From: Katherine Williams
Sent: 03 December 2025 11:03:23 UTC+00:00
To: "'Sophie Hulton-Harrop'" <Sophie.Hulton-Harrop@mottmac.com>
Cc: "Tim Butcher" <Tim.Butcher@mottmac.com>
Subject: RE: DM/25/2283 and DM/25/2472 - Queen Victoria Hospital, Holtye Road, East Grinstead
Attachments: RE: DM/25/2283 and DM/25/2472 - Queen Victoria Hospital, Holtye Road, East Grinstead

From: Sophie Hulton-Harrop <Sophie.Hulton-Harrop@mottmac.com>
Sent: 02 December 2025 13:46
To: Katherine Williams <Katherine.Williams@midsussex.gov.uk>
Cc: Tim Butcher <Tim.Butcher@mottmac.com>
Subject: RE: DM/25/2283 and DM/25/2472 - Queen Victoria Hospital, Holtye Road, East Grinstead

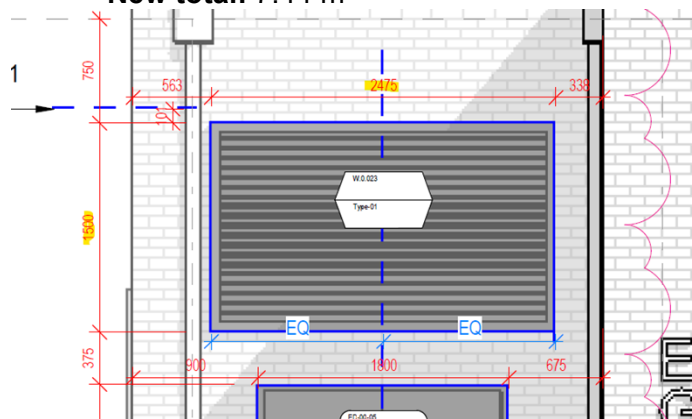
Regarding the updated louver design, please see more detail below.

The areas previously considered for the louvers were:

- **East side (square opening):** 3.44 m²
- **West side (rectangular opening):** 5.40 m²
- Total:** 8.84 m²

Due to clashes with columns and MEP minimum opening requirements, we are now proposing similar-sized openings for both locations:

- **Each opening: 3.72 m²**
New total: 7.44 m²

Please can you confirm that this change would constitute a Non-material Amendment and therefore a S96a application can be submitted?

- The new updated landscape plan is missing the key for the *Balustrade with Handrail Metal railing installed along the access path, including ramp and stair areas. Powder-coated finish (PPC) in RAL 1019*. Can this be clearly annotated.
- Regarding **Louver design** - *changed due to clashes with the structural grid, identified at detailed design stage. The dimensions of the louvers have changed slightly to accommodate the position of the structural columns and other building fabric elements*. Can I ask to describe 'slightly' in some numbers so I can get a better understanding of the scale of impact of this change.

With regards to the changes to the entrance ramp and louvers these amendments would be non-material and a S96a can be submitted. This will need to be submitted and approved before the conditions can be discharged to ensure there is no discrepancy.
